Batch 6 and one question: where the Mirror of Erised's classroom stands; the halls' ceilings; the dungeon passage

The Architect, 14 October 2026, for Godric. Ledger lines 23 and 24, reqs 370 and 382 (docs/architect/changes.md), drawn on the castle model, version 25. Red: what changes. Q 2 taken at 3.15 am, provisional, Godric to confirm, and placed in version 24.

Q 1: inside, over the Entrance Hall, as Interiors drew it (floor 4, 1:250)

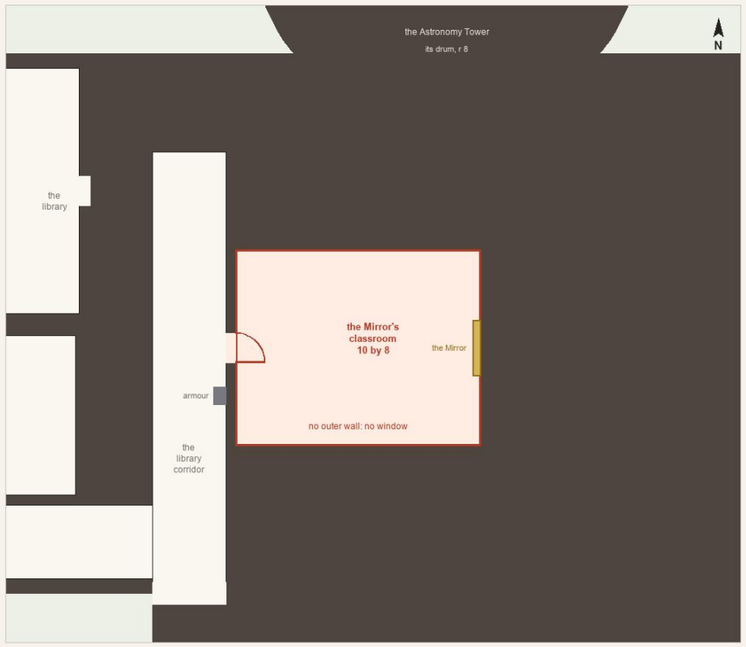
1: inside the north range over the Entrance Hall, as Interiors' key plan drew it. It meets no outer wall, so no window: the books' dark room, but the boys' day visit has no daylight and the later visit no moonlight.

Q 2: north to the tower, one window in the front wall (floor 4, 1:250)

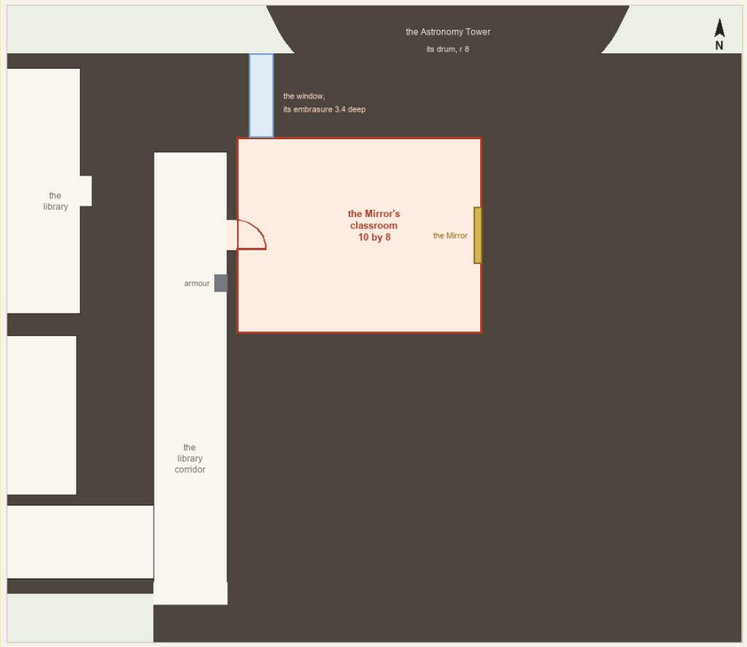
2, recommended: slid 4.6 north, its north wall against the Astronomy Tower's drum. West of the drum the front wall is free, so one window, 1.0 wide, sill 1.2, goes through it in a deep embrasure at the door end of the left wall, never behind the Mirror or facing it. Its light falls on the floor just inside the door, and the Mirror, facing the door, holds the lit window in its glass. Day first, moonlight later (a pale glow: a north window takes no direct moon), as Magic's thread asks.
